SI B18 02 12  
Exhaust Systems

March 2013  
Technical Service

**Voluntary Emissions Recall Campaign 11E-A03: Check and/or Replace Emissions Monitoring Components**

E70 and E90 with the M57Y engine produced from January 2008 to September 2009

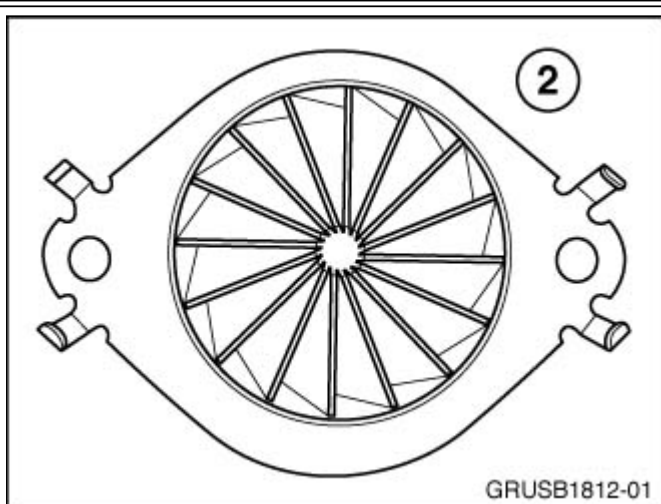
need to be replaced with P/N 18 30 8 513 445 (E70) or P/N 18 30 8 512 438 (E90).

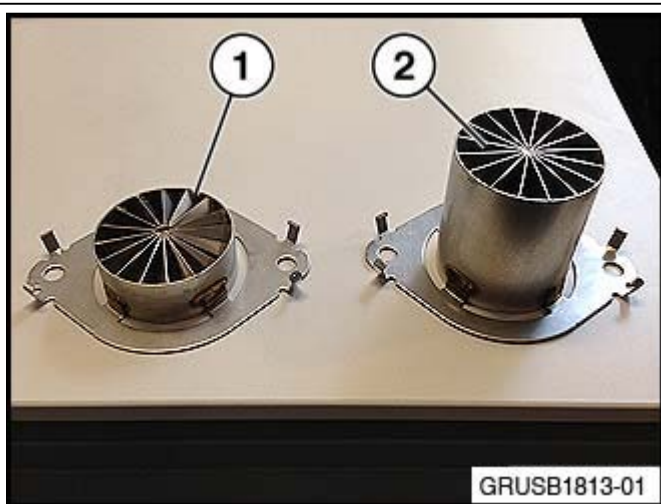
If the updated mixer has already been installed, it will have one set of fins (2). No replacement is necessary. Reinstall the SCR front pipe to the down pipe of the DPF.

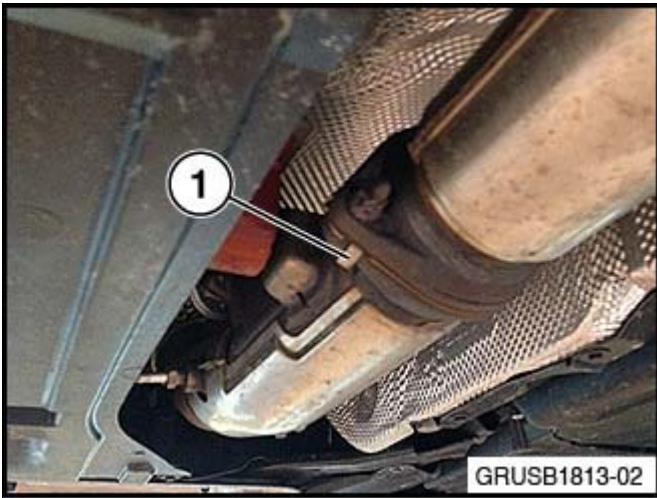
**NEW** The mixer for the E90 (1) is shorter than the E70 mixer (2).

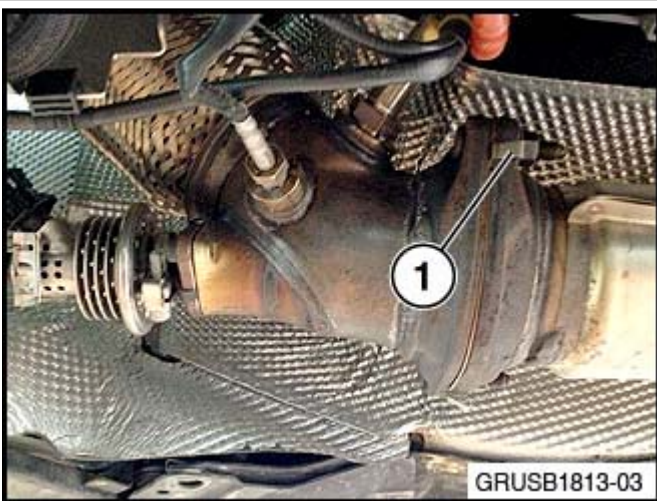
**NEW** The barrel of the E70 mixer points toward the front of the car. This is easily identified by the mixer tabs wrapped around the front pipe flange (1).

**NEW** The barrel of the E90 mixer points toward the rear of the car. This is identified by the mixer tabs wrapped around the flange on the SCR cat (1).

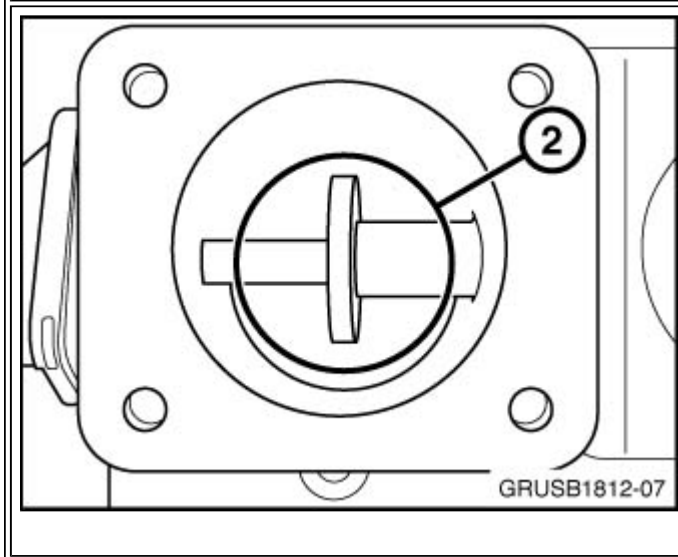
The updated EGR valve (P/N 11 71 8 517 217 or P/N 11 71 8 512 526) has the valve and seat directly in the airstream of the throttle (1). If this valve is installed, no further action is needed. Reinstall the charge air pipe.

The original EGR valve has a diffuser in the airstream flow from the throttle (2). The valve for EGR actuation is seated further into the EGR airstream. Replace this valve with P/N 11 71 8 512 526 (Repair Instruction 11 71 501).
